# Tween Bridge Solar Farm

## 9.9 Statement of Common Ground with Natural England

**Document Reference: 9.9**

**Revision 1**

Figure 1: 16413\_P16a\_600m Buffers\_TLR\_RR

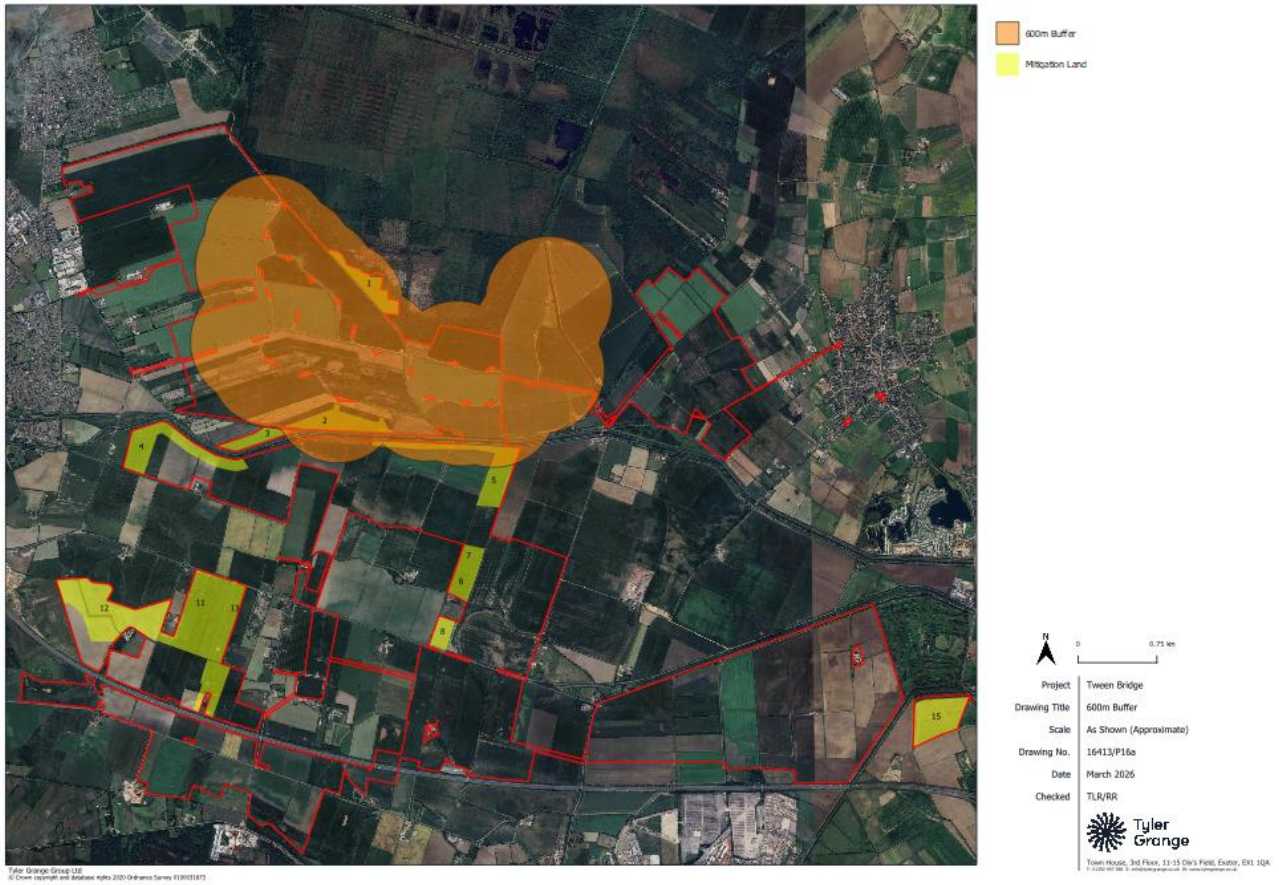
<p>of the carrying capacity of different habitat types.</p> <p>For information, we highlight that golden plover and lapwing rely on open vistas to forage, and the relevant mitigation areas should seek to deliver this site characteristic to ensure suitability for these species. Golden plover tend not to use fields less than 10ha, and fields 15–30ha or larger are used more often especially when in flocks of over 100 birds<sup>2</sup>.</p> <p>We advise that existing habitat suitability should be factored into the assessment of the proposed mitigation areas. We recommend that the design of mitigation areas should take into account potential benefits of securing areas of higher existing bird usage as mitigation areas through enhancement, rather than the establishment of entirely new habitats which have a lower usage baseline. For example, the <i>Wintering Bird Survey Results – 2023 to 2024 (Lapwing)</i> show significant lapwing usage of the southernmost point of the site in both years of surveys.</p>	<p>The Applicant confirms that Bird Days calculations have been used as a tool to inform the approximate mitigation area required, alongside ecological knowledge of the carrying capacity of different habitat types. Further detail is provided within the <b>Report to Inform Habitat Regulations Assessment [Document Reference 5.3 Revision 3]</b>.</p> <p>Surveys undertaken demonstrate that golden plover are not a functionally linked species and therefore no species-specific mitigation is required. However, the mitigation areas have been designed to provide open vistas suitable for lapwing, which will also provide suitable habitat for golden plover.</p> <p>Section 2 of the Non-Breeding Bird Mitigation Strategy submitted as <b>Environmental Statement Appendix 7.10 Non-Breeding Bird Mitigation Strategy [Document Reference 6.3.7.10 Revision 2]</b> sets out calculations of land availability with 150 m open vistas, with this information also included within the <b>Report to Inform Habitat</b></p>

<p><b>Regulations Assessment [Document Reference 5.3 Revision 3]</b> and provided as part of Figure 1 within this document.</p> <p>Several mitigation parcels larger than 10ha with at least 150 m open vistas are provided, including M12 and M13.</p> <p>A total of 43.67ha of mitigation land with 150 m open vistas is located beyond 600 m of wind turbines, in line with point NE3 (see below), and is available for lapwing. Bird Days calculations demonstrate that 24.99 ha is required for lapwing (Appendix 2 of the <b>Report to Inform Habitat Regulations Assessment [Document Reference 5.3 Revision 3]</b>) confirming that more mitigation land is provided than required. Additional mitigation land within 600 m of turbines, including parcels M1 and M2, is also available, and lapwing have been recorded using these areas, therefore ensuring that additional land is available for this species.</p> <p>When considering mitigation land beyond 600 m of turbines, 108.84ha remains available for pink-footed</p>
